STATE	PROJECT DESIGNATION	YEAR	SHEET NO.	TOTAL SHEETS
ALASKA	BRF-037-2(19)	1971	63	74

AS BUILT PLANS

NENANA RIVER BRIDGE
AT PARK BOUNDARY
Route No. F-37
GENERAL LAYOUT

BRIDGE NO. 694
DWG. NO. 2390

Date: 4/2/72
Approved: [Signature]

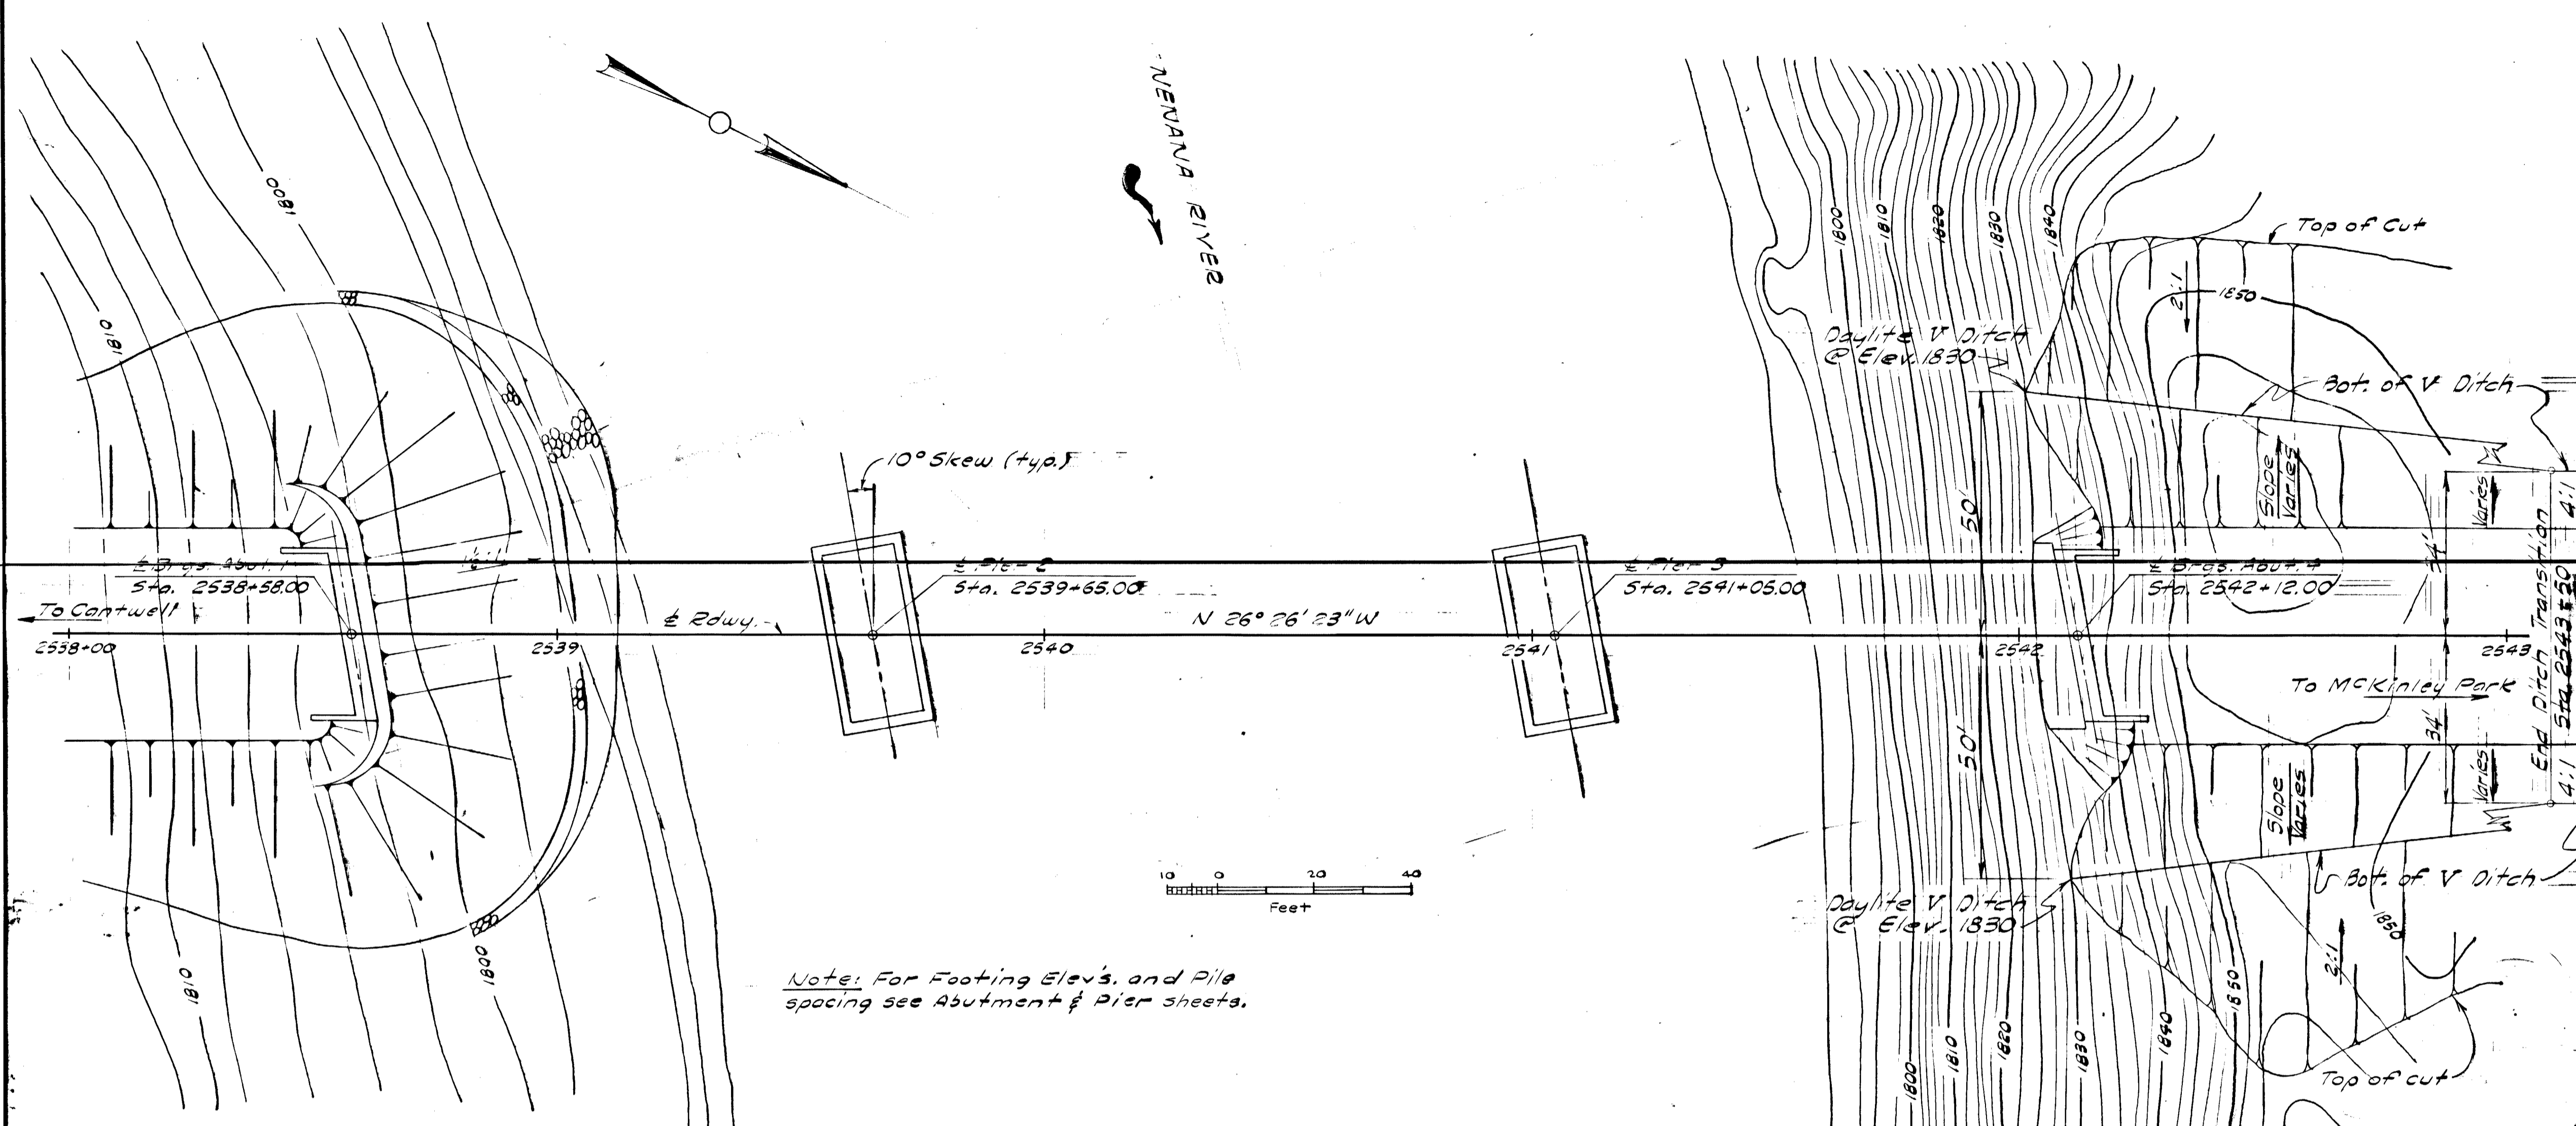
Note:
Due to lack of Camber in the Structural Steel, Bridge grades at each pier were lowered 1/4" & feathered out toward each abut.

NENANA RIVER BRIDGE
 AT PARK BOUNDARY
 Route No. F-37
 SUPERSTRUCTURE

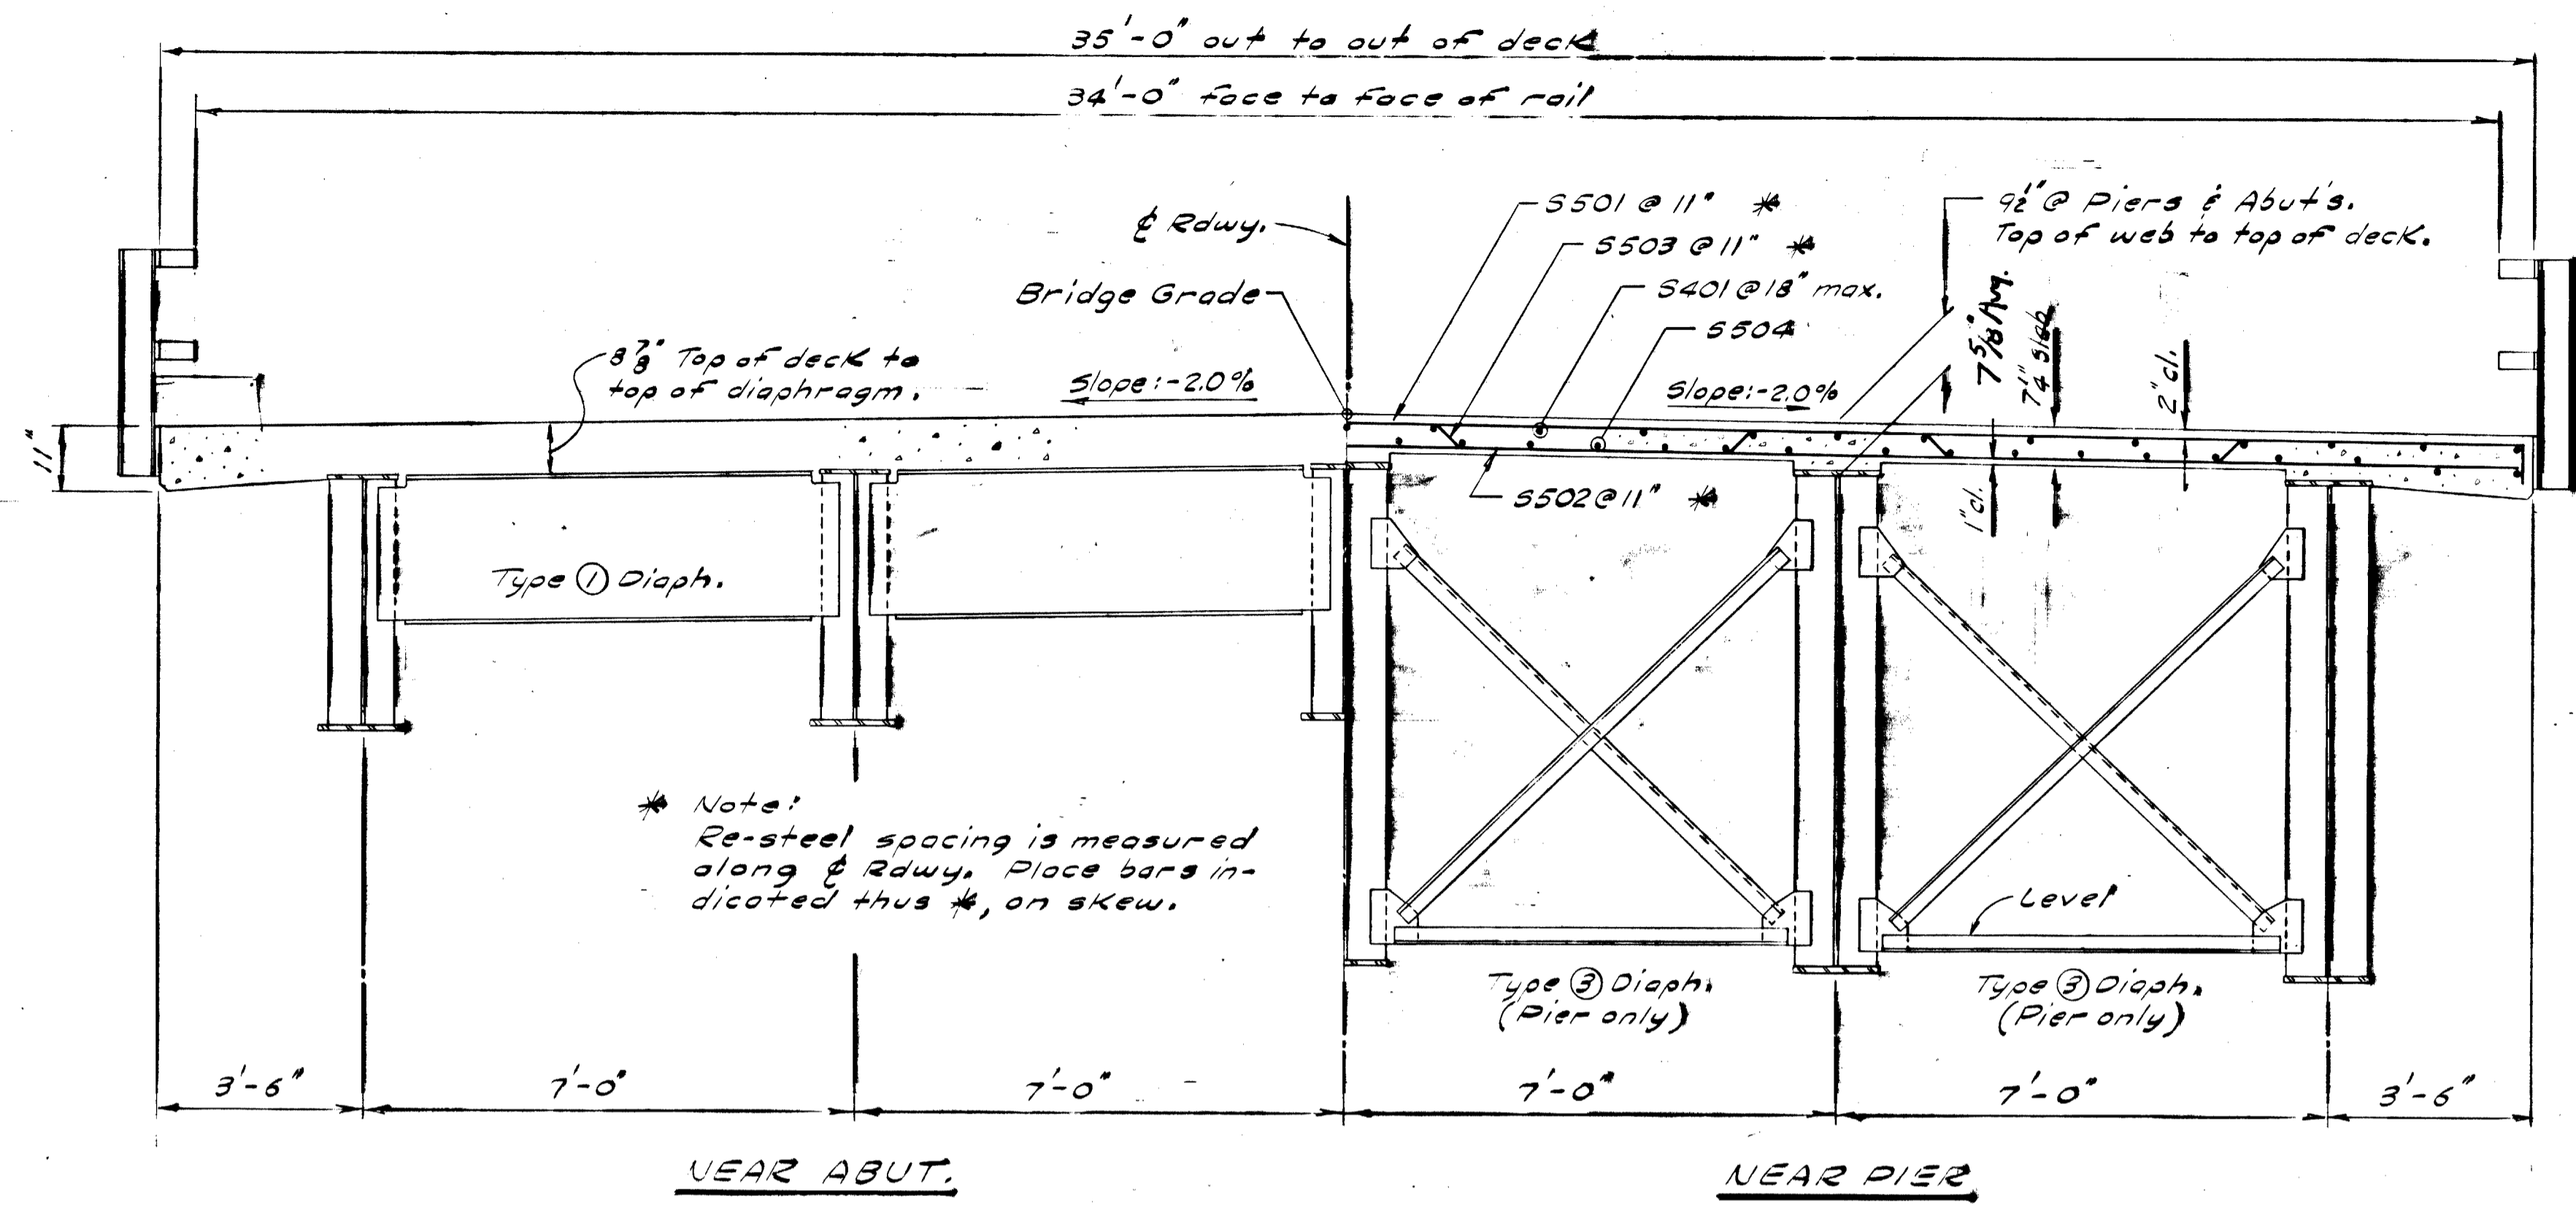
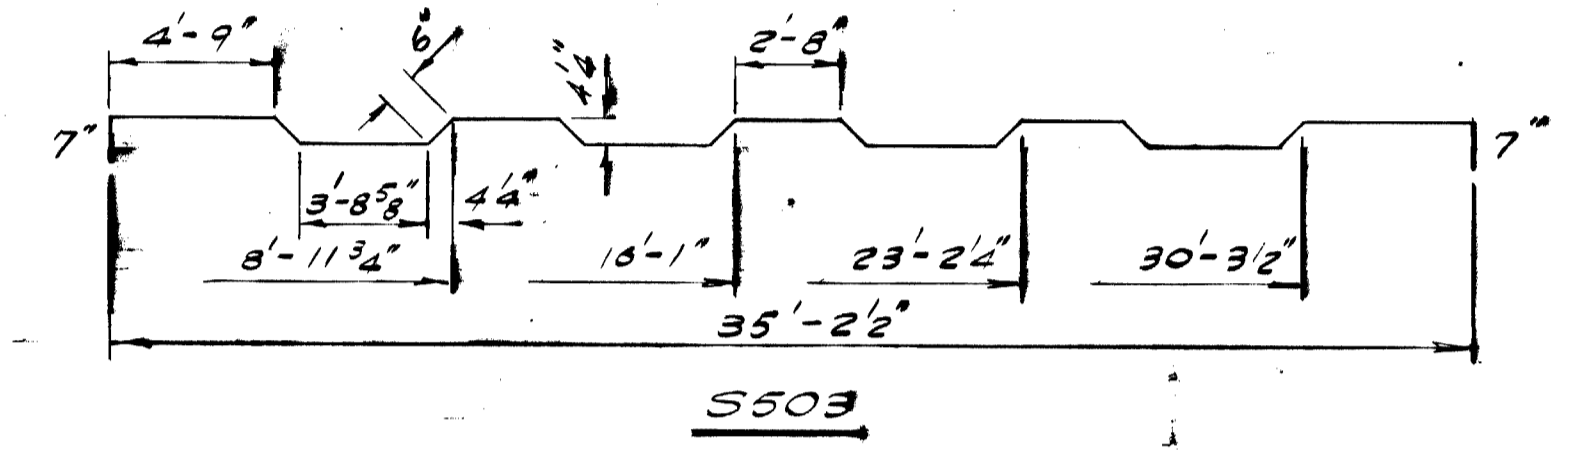
NOTE:
 Because S.I.P's were used to form the deck, slab thickness was increased 3/8" & deck re-steel was perpendicular to centerline.

CAMBER DIAGRAM

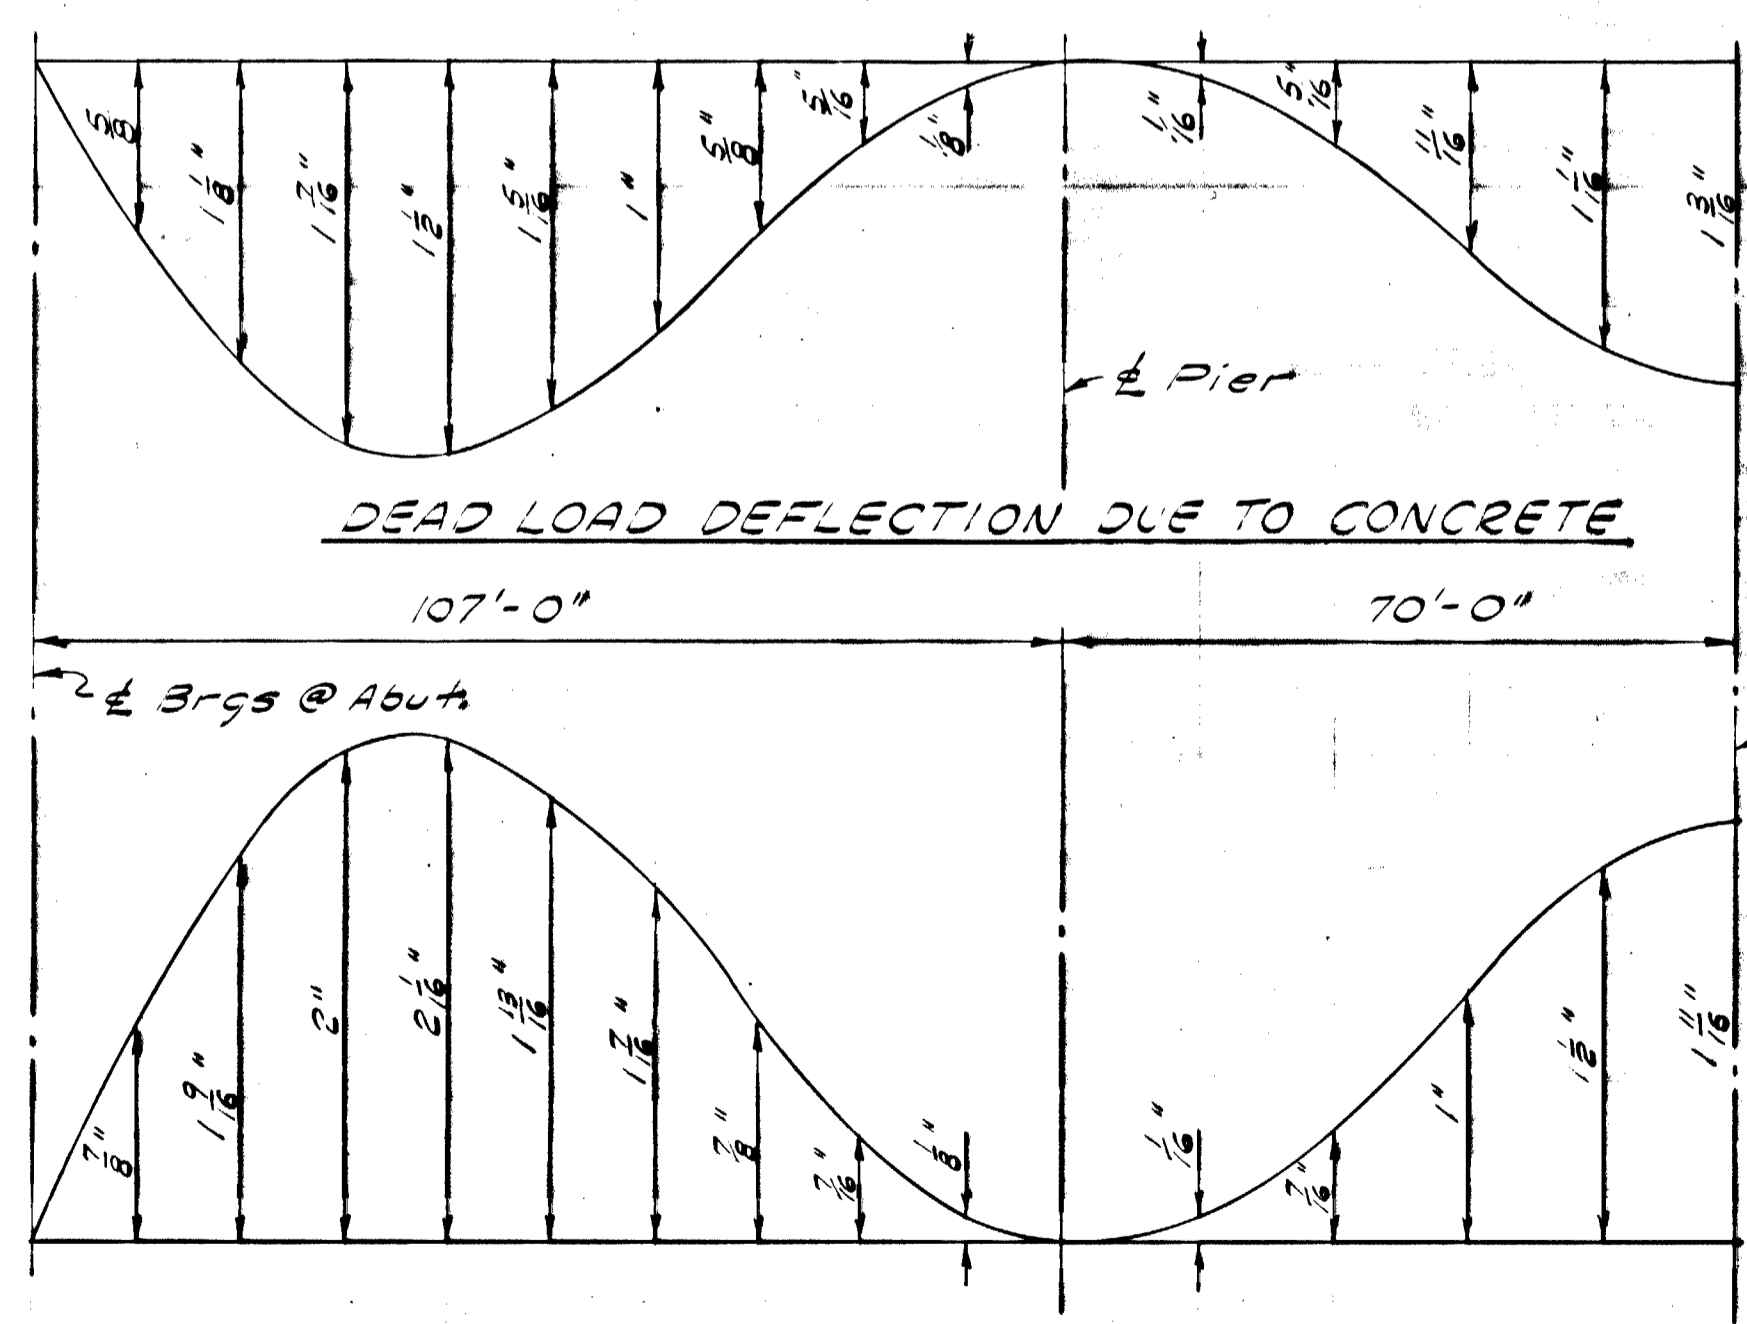
Structural Steel was fabricated with no camber
